ADDENDUM NO. [2]

Date: September 17, 2019

**RE: SCHOOL DISTRICT OF LA CROSSE
7 RIVERS CHARTER SCHOOL
225 5TH AVE SOUTH
LA CROSSE, WI 54601
HSR 19003**

10. Sheet A090 DEMOLITION PLANS 30 x 42 attached hereto

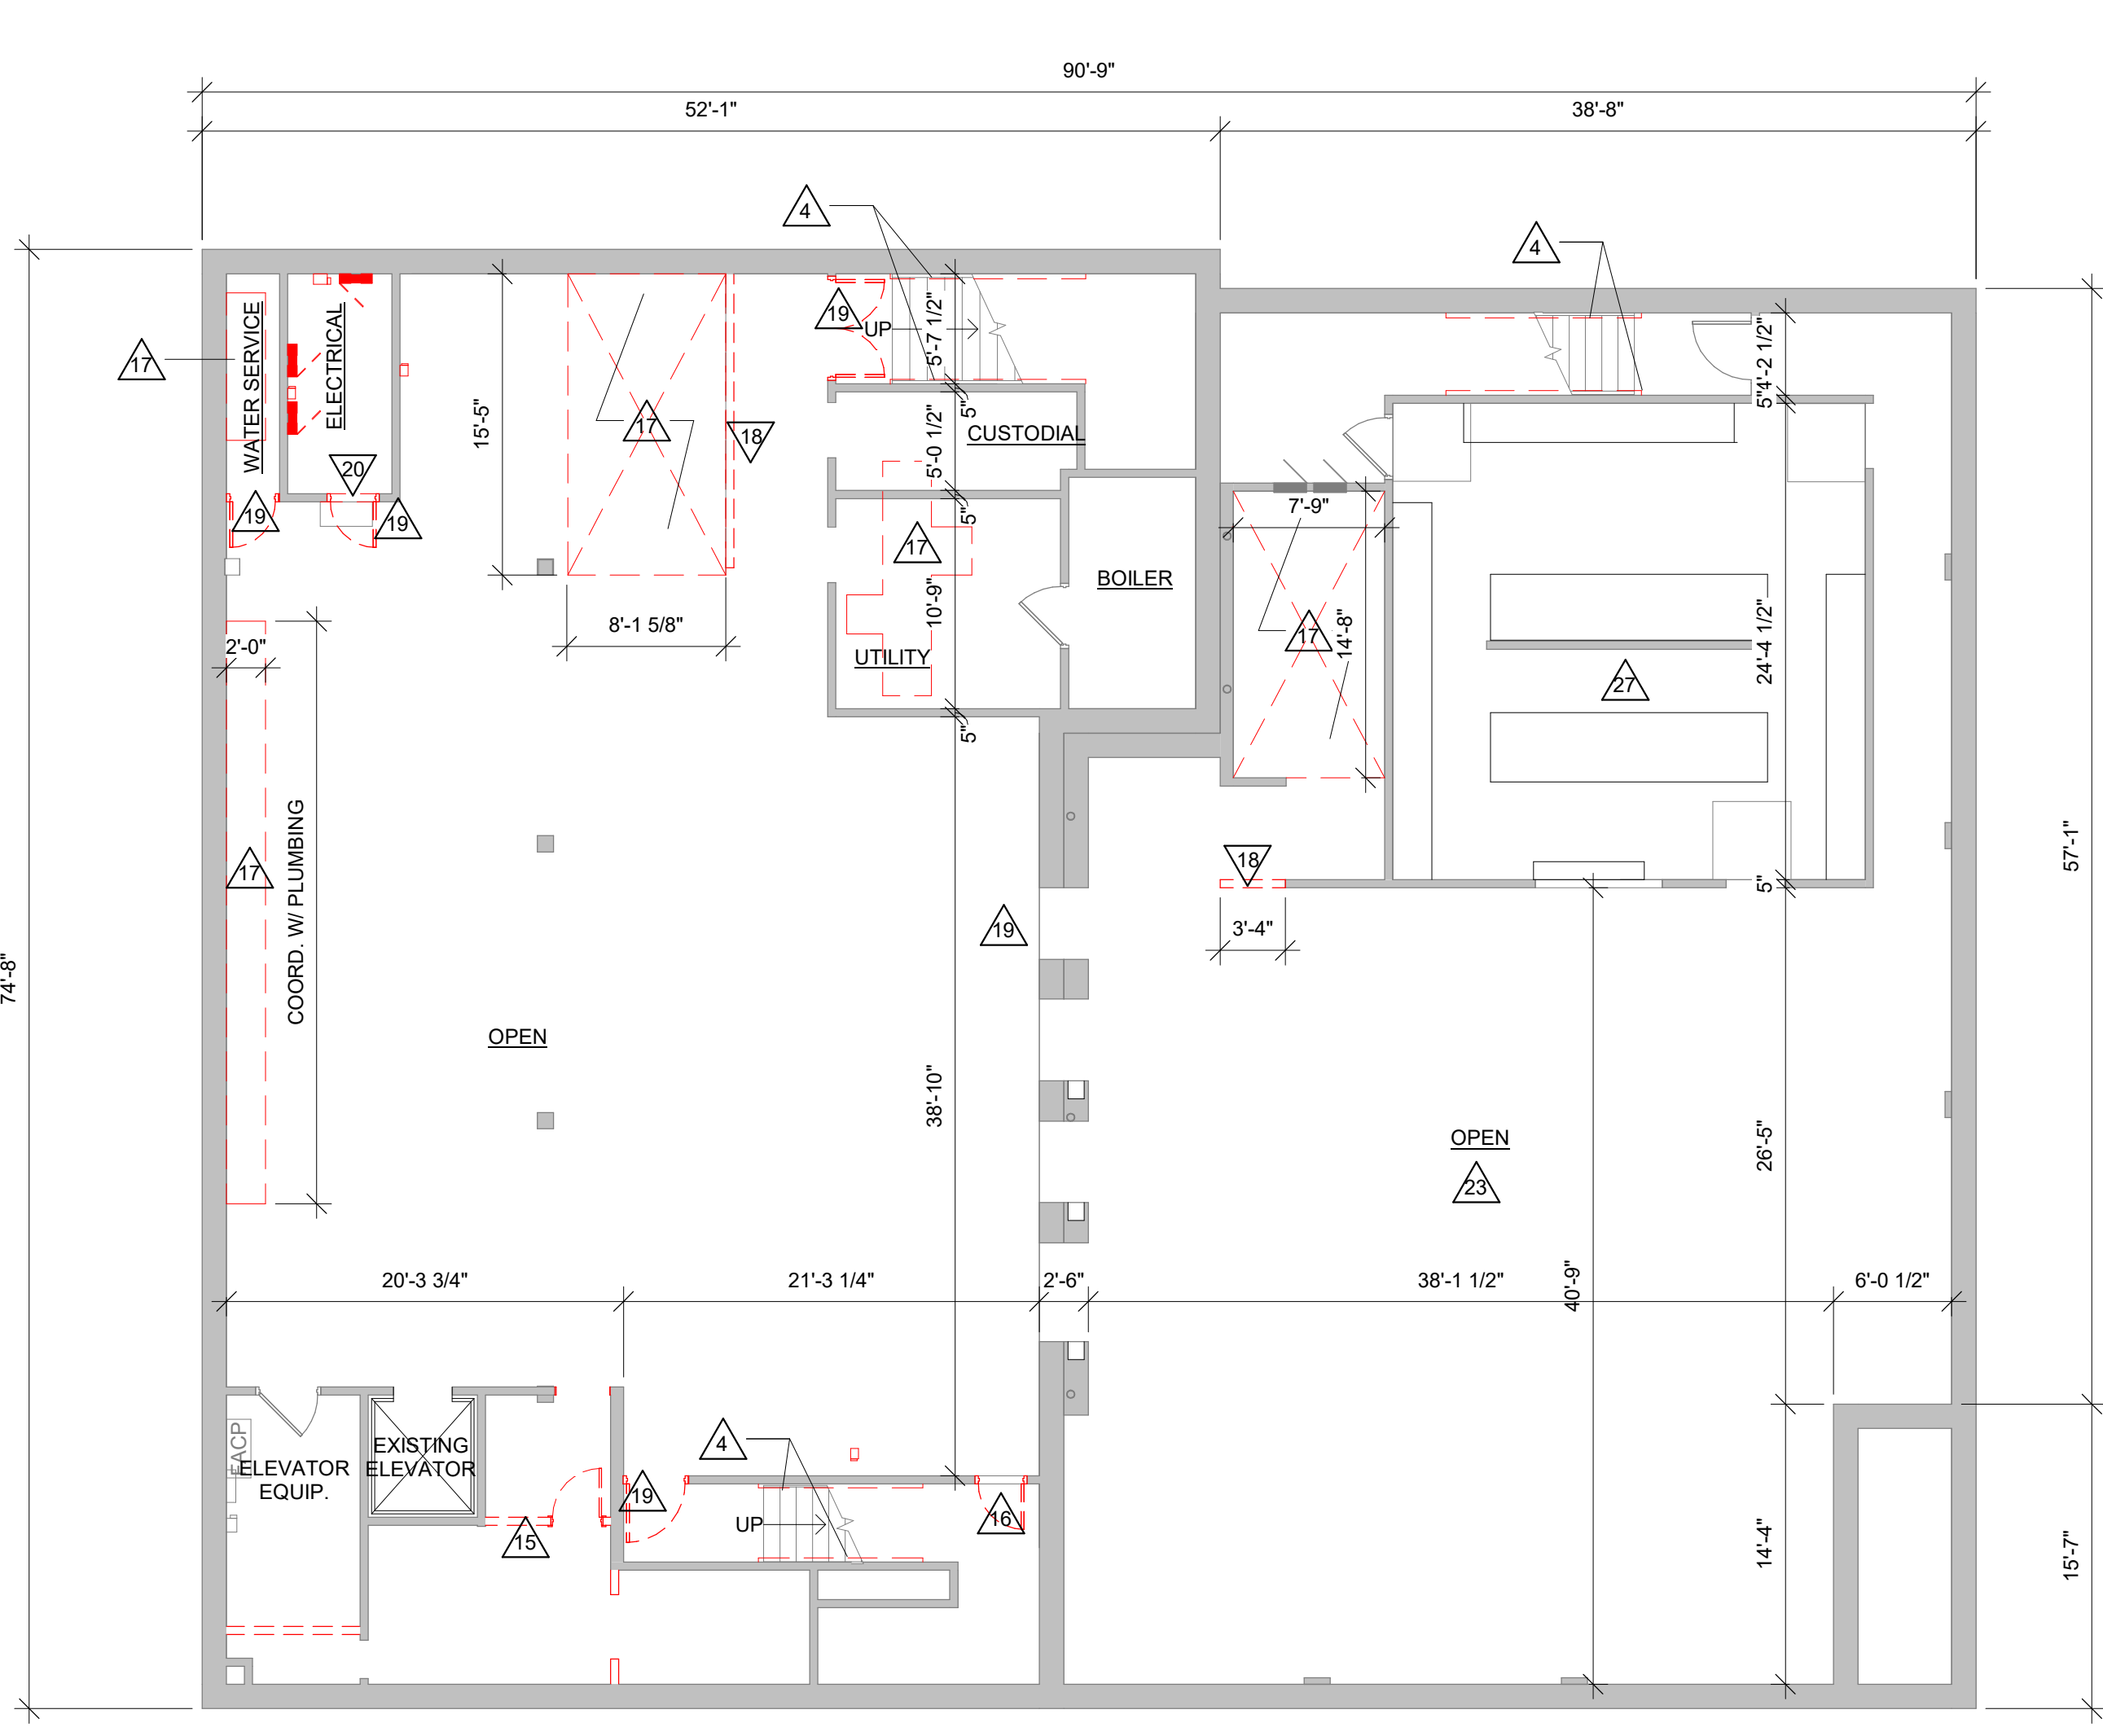
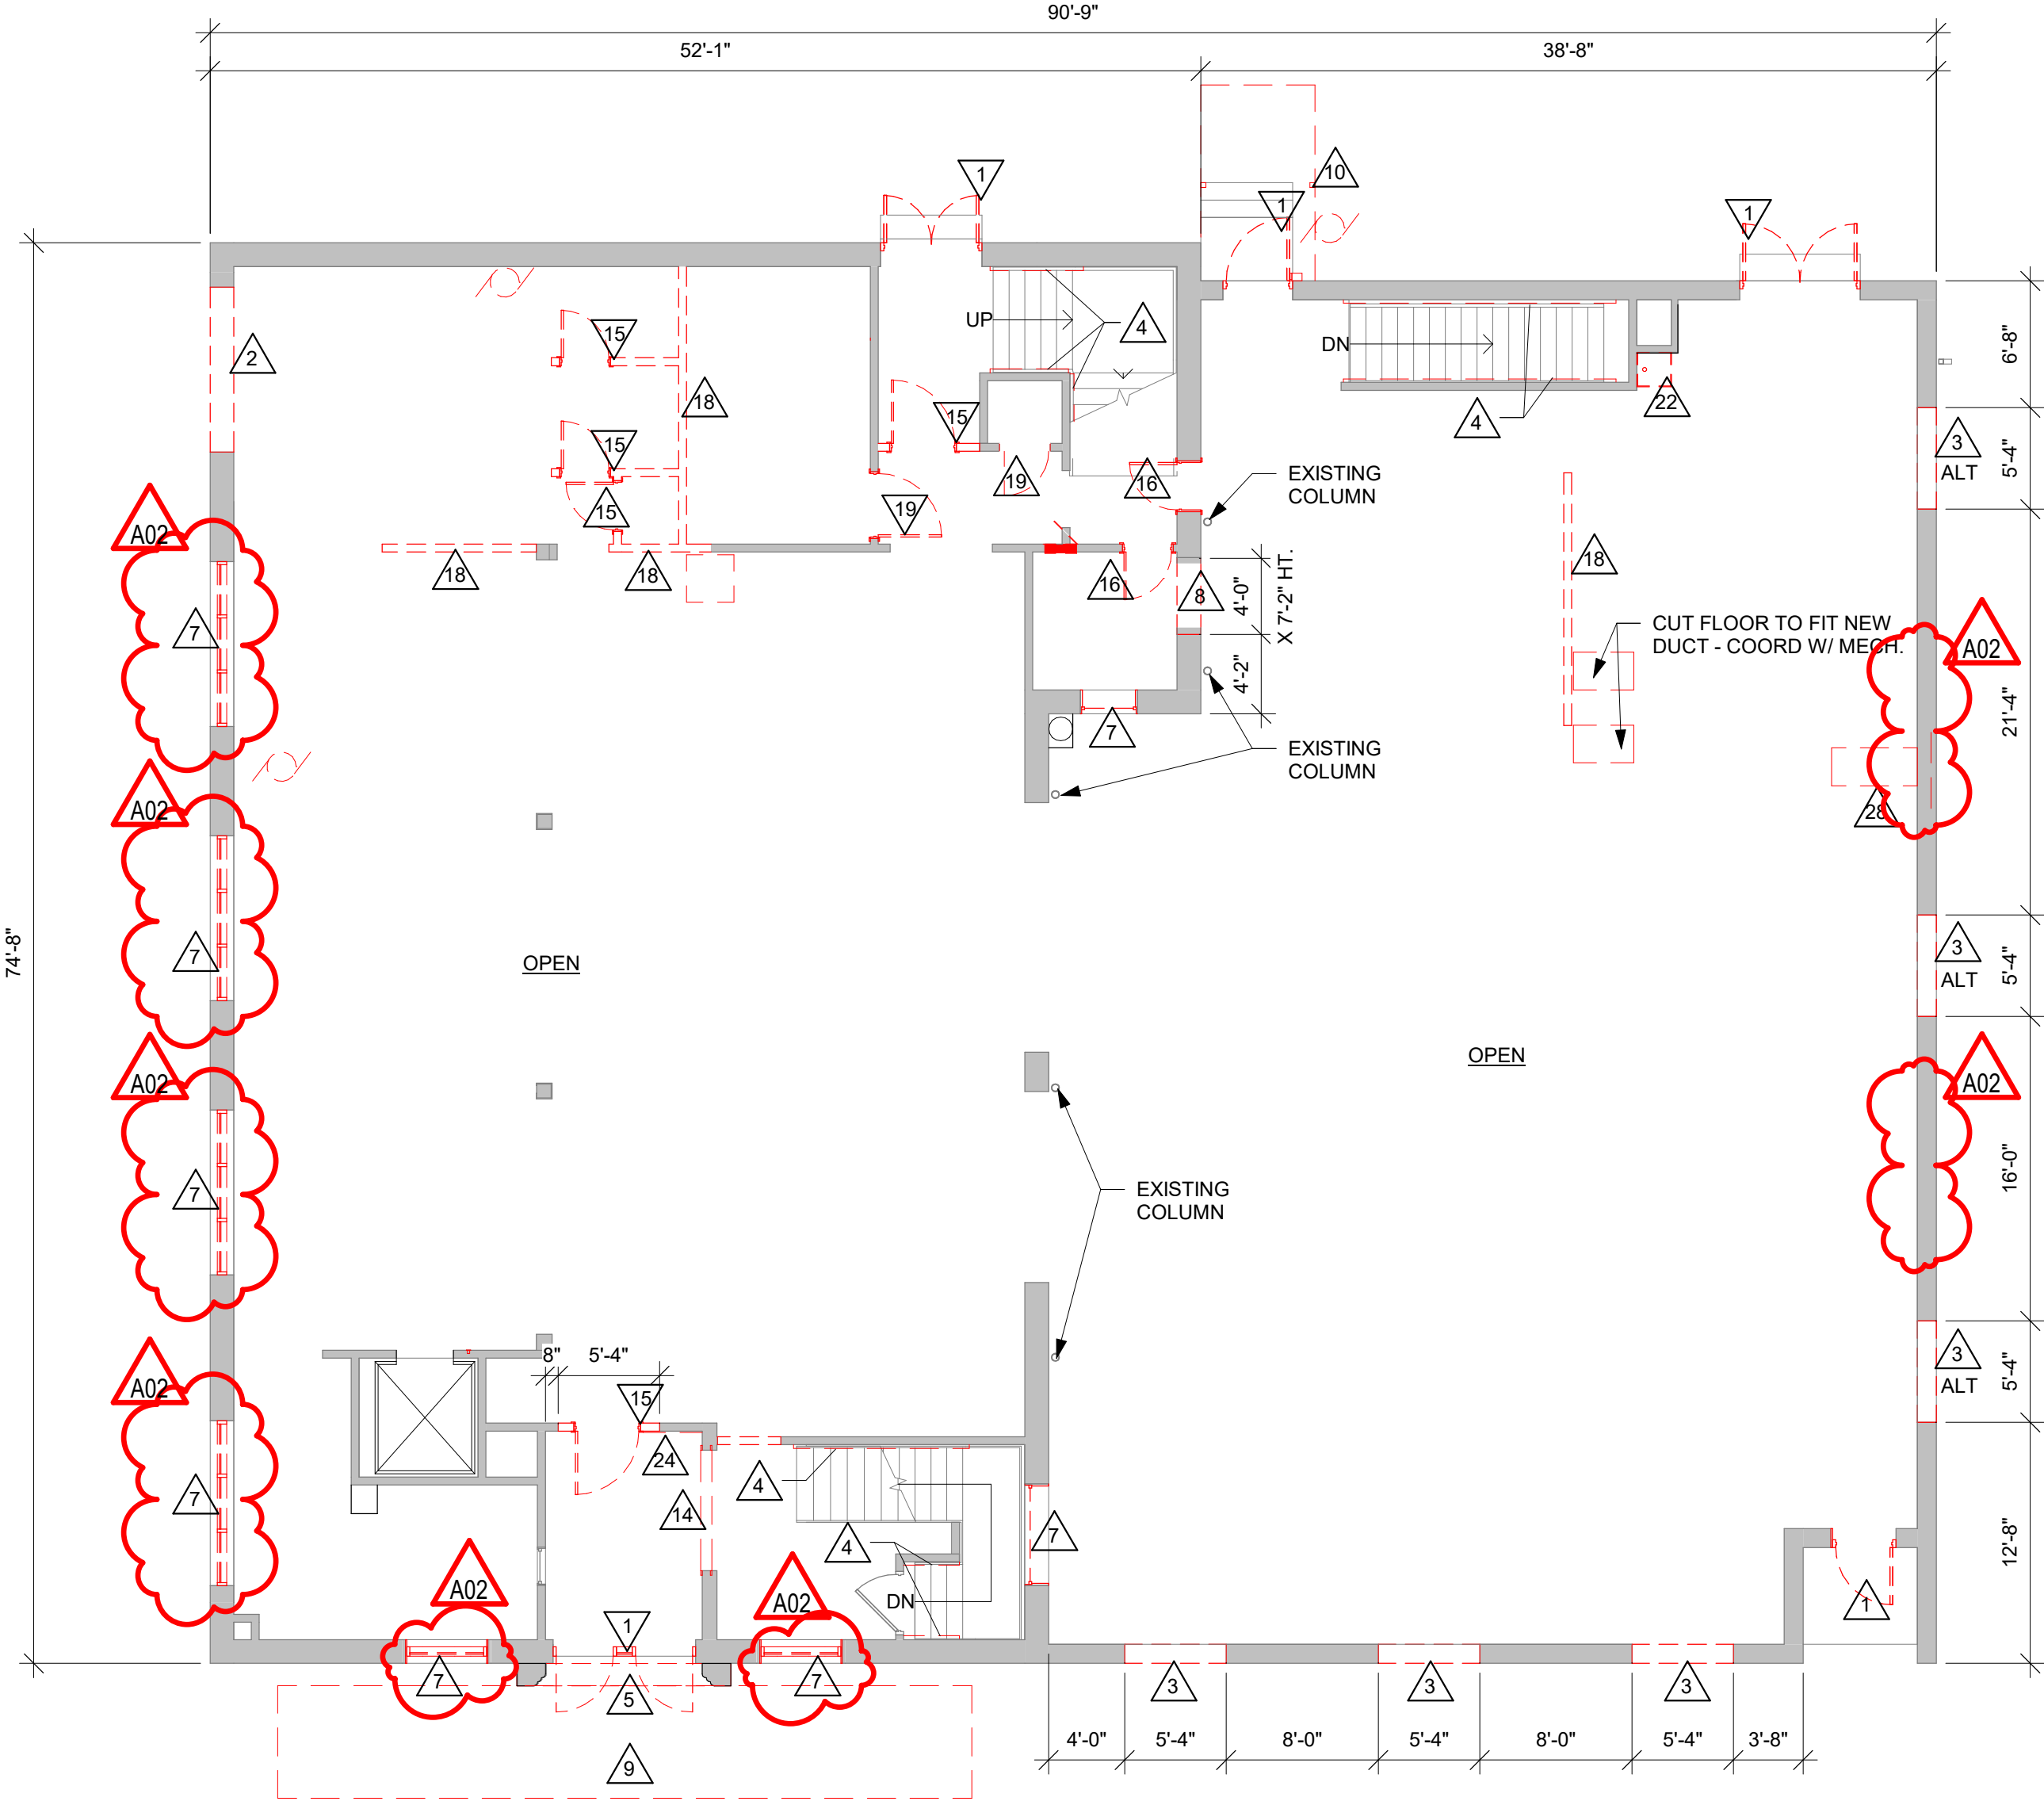
- a. Revisions clouded on Drawing.
- b. All existing windows shall be replaced.
